Woodmont View, Limited Site Plan Amendment, 82009001A

Limited Site Plan Amendment No.82009001A:
Woodmont View

Request to amend Site Plan: 820090010 to
waive the parking requirement for commercial
uses, modify the recreation facilities and
modify the building elevation elements

Staff Recommendation: Approval with
Conditions

Facade Study

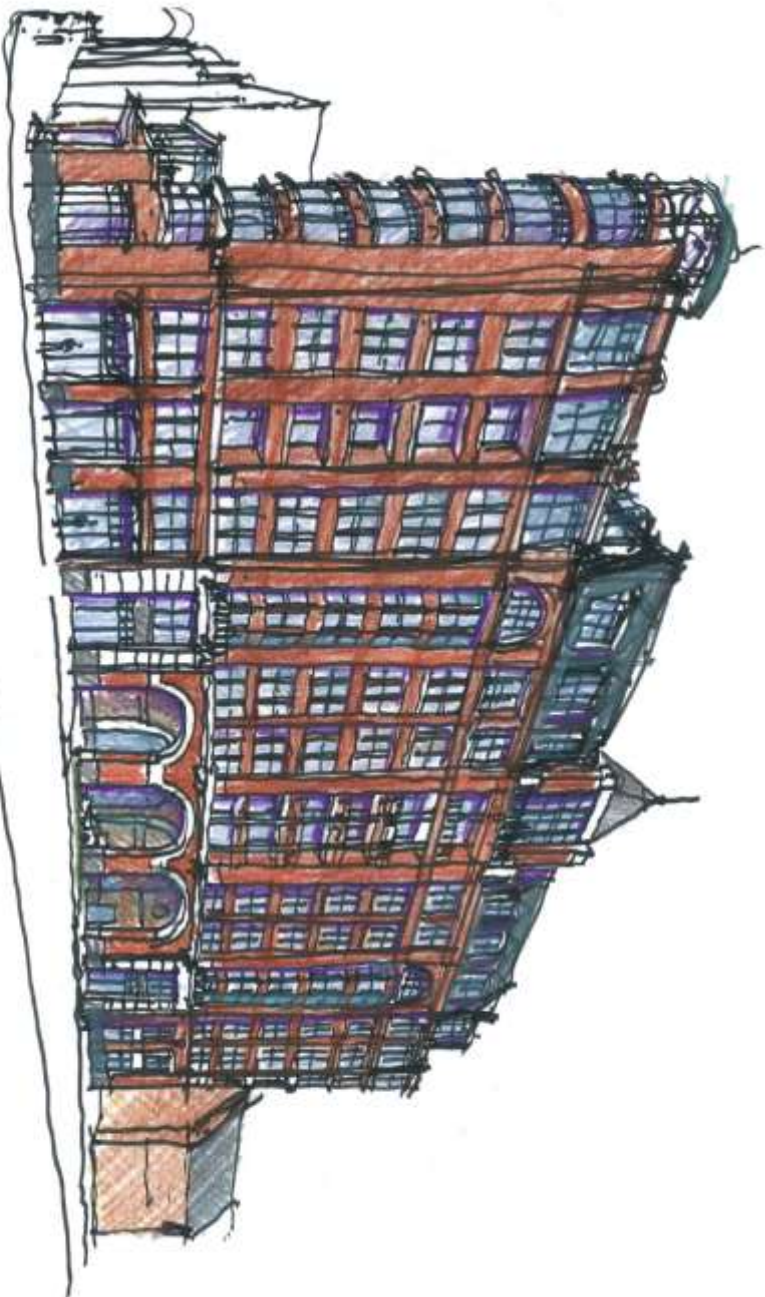
5. Revise the building façade elements in accordance with the submitted sheet no. 2.0 dated 06/12/2013. The massing and height of the building on the previously approved site plan submission must be maintained. The façade elements will be substantially similar to the elevations that were previously approved.

- The Applicant requests to refine the building elevations. The building façade will have a clearly defined base, middle and top. The tripartite design will be reinforced by rich building materials such as granite and cast stone at the base, brick and cast stone detailing in the middle, as well as a clearly defined cornice at the top. The massing and height of the building on the previously approved site plan submission must be maintained. The façade elements will be substantially similar to the elevations that were previously approved. The revised building Woodmont View elevation is shown in Figure 3 on page 7.
